Euclid House RUE PLN51139 RUE

Project Euclid House RUE
File No. PLN51139 RUE
Date April 11, 2019
To City of Bainbridge Island Hearing Examiner
Project Manager Annie Hillier, Planner

Request	The request is for a reasonable use exception (RUE) on a lot that contains a category IV wetland and associated buffer, for the development of a single-family residence.
Address	**no situs address**, Bainbridge Island, WA 98110
Tax Assessor #	41670000240003
Environmental Review	The project is exempt from the State Environmental Policy Act (SEPA) under WAC 197-11-800(1)(b)(i).

Figure 4 – Mitigation proposal

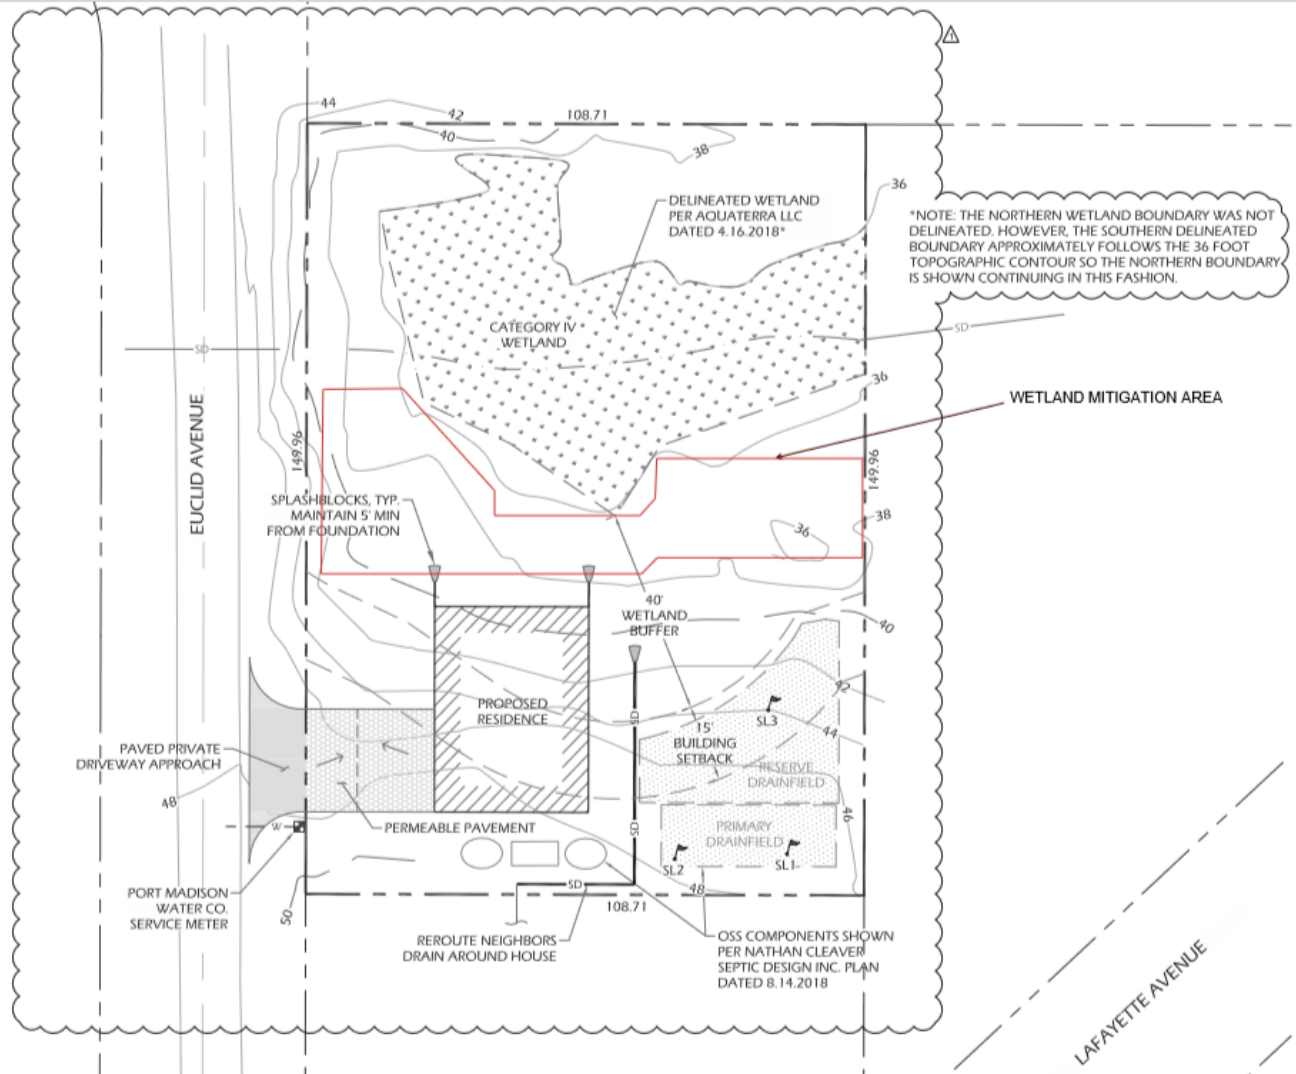
Staff response: Wetland mitigation plan requirements are provided in BIMC 16.20.180.G. Note that a replanting ratio of 1.5:1 is not required, as stated in the mitigation plan. Rather, the mitigation plan is required to contain goals and objectives that are related to the functions and values of the original critical area, in accordance with BIMC 16.20.180.G.3.b. As described in the mitigation report, “much of the existing buffer consists of non-native plant species, English ivy (*Herdera helix*) and dead nettle (*Lamium galeobdolon*).” However, a discussion of the functions and values of the original critical area is not provided.

To compensate for the impact to the wetland buffer, the applicant is proposing to remove invasive vegetation on the site, and to install native vegetation within an 1,800 sq. ft. area. While this may be adequate to compensate for the loss of wetland buffer function, it is not clear from the mitigation plan what those functions are. It is also not clear in what area the invasive species will be removed – the entire buffer and wetland, or only in the replanting area. Staff also observed a significant amount of English laurel on the site, an invasive species that is not identified in the mitigation plan.

- A final mitigation plan shall be submitted and approved prior to the issuance of any permits for development, vegetation removal, land clearing, or grading. The final mitigation plan shall address the criteria under BIMC 16.20.180.G.3.b, Environmental Goals and Objectives, including: identification of functions and values; a complete description of the relationship between and among structures and functions sought; review of available literature and/or known like projects to date in restoring or creating the type of critical area proposed; likelihood of success of the proposed compensation project at duplicating the original critical area; and likelihood of the ability of the created or restored critical area to provide the functions and values of the original critical area. (Condition 5)

- The final mitigation plan shall clarify the area in which invasives species will be removed. Consideration shall be given to removing invasive species throughout the project site to the maximum extent practicable, to improve the likelihood of success of the mitigation plan. If this is deemed infeasible, justification must be provided and the likelihood of success must be discussed. Any bare areas after invasive species removal shall be replanted with native vegetation, in addition to the native species proposed to be planted with the 1,800 sq. ft. mitigation

area. Consideration shall also be given to removing the English laurel on the site, and any other invasive species that may be present. (Condition 6)
